**BCA & ACCESS ASSESSMENT REPORT**  
*SSDA Design*

**The Sutherland Hospital  
Operating Theatre Upgrade Project**

**Health  
Infrastructure**

Date: 18 December 2020

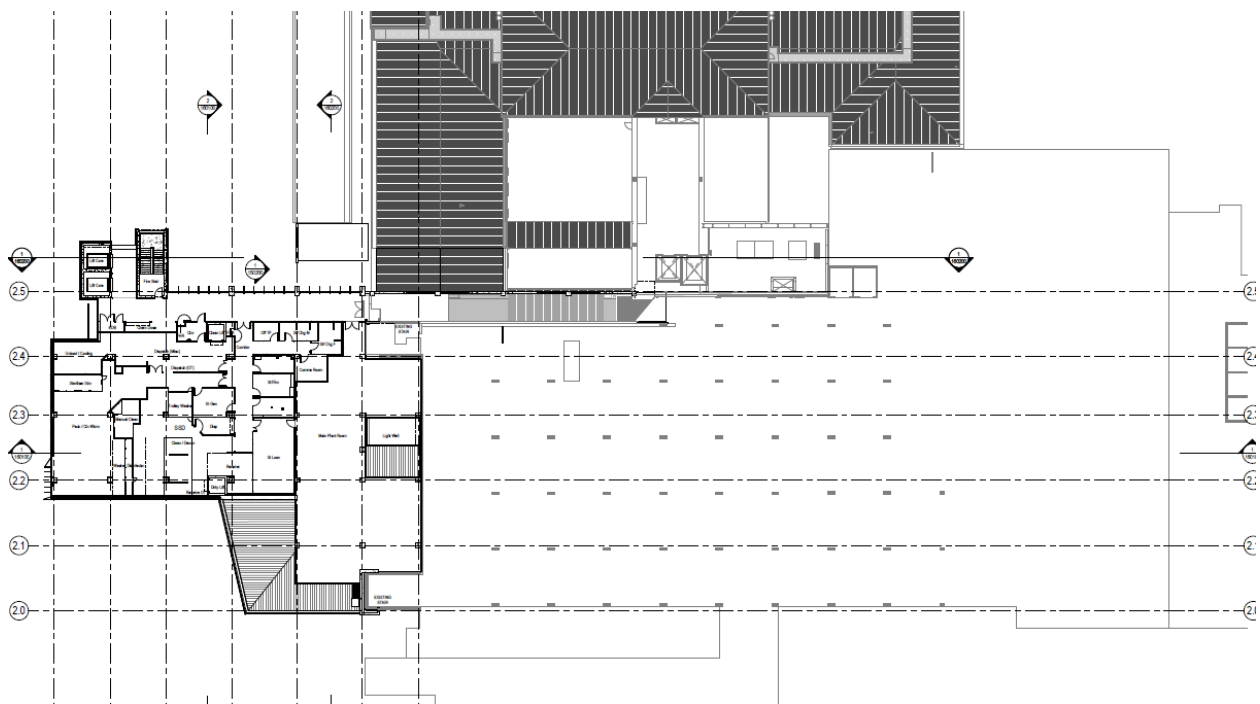
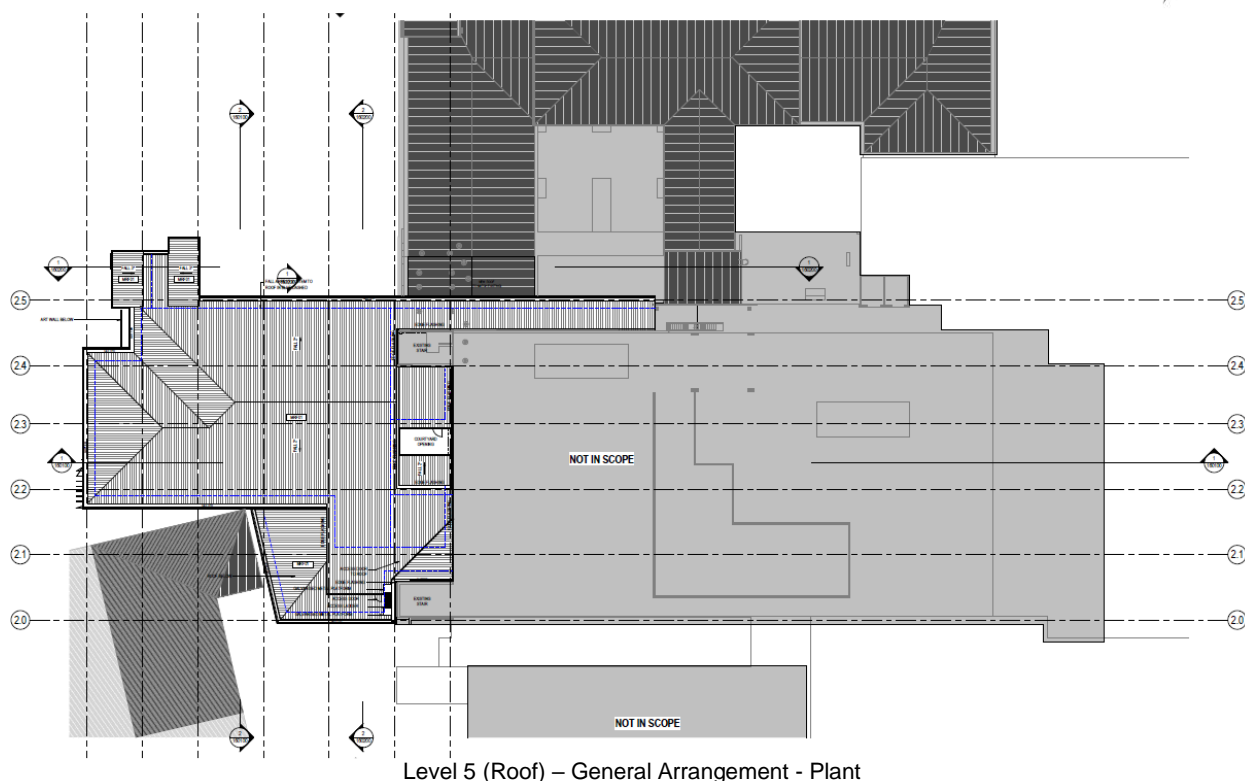
There are a number of proposed smoke walls in levels 3 & 4 that will need to be upgraded to fire walls to assist with egress (horizontal exits) These are marked up above.

## C2.5

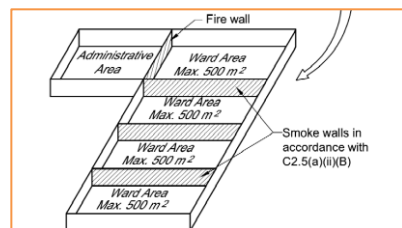
Patient care areas need to be separated into maximum 2,000m<sup>2</sup> fire compartments by fire walls having an FRL of 120/120/120. Non-patient care areas may be increased to maximum 5,000m<sup>2</sup> fire compartments.

- i) Where the floor area exceeds 1,000m<sup>2</sup>, then it must be divided into compartments of not more than 1,000m<sup>2</sup>, by walls with an FRL of not less than 60/60/60, and
- ii) Where the floor area exceeds 500m<sup>2</sup>, then it must be separated into further compartments of not more than 500m<sup>2</sup>, by smoke proof walls complying with the requirements of Specification C2.5, and

- B. Treatment areas must be divided into compartments of not more than 1,000m<sup>2</sup>, by smoke proof walls complying with Specification C2.5.

The new works are predominately treatment areas (perioperative).
